Access Compliance Report

Public Rights-of-Way

(Curb Ramps)

Intersection ID: 8697	Main Street: HOLLAND_AV	Cross Street: ISENHOUR_ST	Location: SE
ADA ID: 885DD6213CA6	Ramp Type: BlendTrans1	Initial Pass/Fail: Pass	Overall Compliance: No
		Severity Score: 22.5	
Codes/Mitigation Info/Possible Solution		Field Measurements/Component Compliance

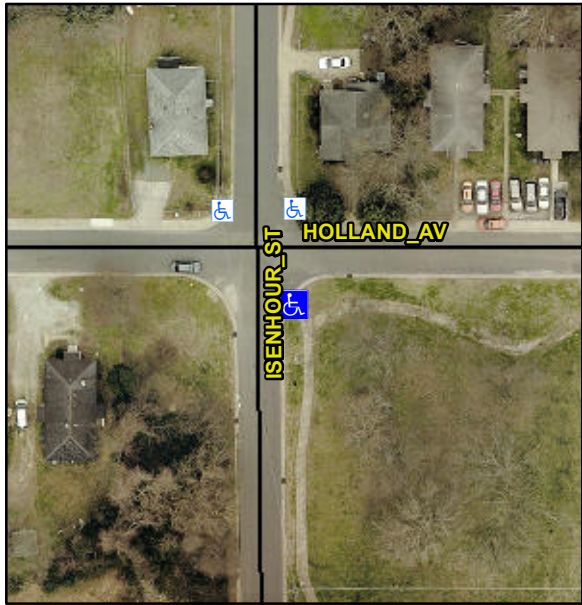
Compliance	Description	Data	Compliance	Description	Data																																																																																																																																																																																
N/A	Ramp Length (in)	30.0	Yes	BlendTrans Slope (%)	3.2																																																																																																																																																																																
Yes	Ramp Width (in)	72.0	Yes	BlendTrans XSlope (%)	1.8																																																																																																																																																																																
N/A	Flare Type LT	Sloped	N/A	Flare Type RT	Sloped

N/A	Flare Slope LT (%)	2.3	N/A	Flare Slope RT (%)	6.1																																																																																																																																																																																
N/A	Flare Traversable LT?	No	N/A	Flare Traversable RT?	No																																																																																																																																																																																
No	Landing Length (in)	46.5	No	DWS Provided?	No																																																																																																																																																																																
Yes	Landing Width (in)	103.0	N/A	DWS Contrast?	No

Yes	Landing Slope (%)	0.6	N/A	DWS Length (in)	N/A																																																																																																																																																																																
Yes	Landing X Slope (%)	1.4	N/A	DWS Full Width?	No																																																																																																																																																																																
N/A	Landing Curb? (Y/N)	No	N/A	DWS Offset (in)	N/A																																																																																																																																																																																
N/A	Shared Landing?	No																																																																																																																																																																																			
Yes	Gutter Ponding?	No	No	Gutter Slope (%)	6.2

No	Gutter Lip Ht (in)	0.5	No	Gutter X Slope (%)	2.5																																																																																																																																																																																
N/A	Painted X Walk1?	No	N/A	Painted X Walk2?	No																																																																																																																																																																																
	X Walk 1 Direction	To N		X Walk 2 Direction	To W																																																																																																																																																																																
	X Walk 1 Width (in)	N/A		X Walk 2 Width (in)	N/A																																																																																																																																																																																
	X Walk 1 Slope (%)	1.6		X Walk 2 Slope (%)	N/A

X Walk 1 X Slope (%)	3.8		X Walk 2 X Slope (%)	N/A																																																																																																																																																																																
N/A	Ramp inside XWalk1?	N/A	N/A	Ramp inside XWalk2?	N/A																																																																																																																																																																																
	Road Slope (%)	N/A		Clear Space?	Yes																																																																																																																																																																																
	Road X Slope (%)	N/A	N/A	Clear Space to XWalk (in)	N/A

Yes	Any Obstructions?	No	Yes	Storm Grate/Utility Hazard?	No																																																																																																																																																																																
	Obstruction Type			Storm Grate/Utility Type																																																																																																																																																																																	
			N/A		N/A																																																																																																																																																																																
			Yes	Surface Condition? (G/P)	Good																																																																																																																																																																																
			No	Curb Slope (%)	12.7
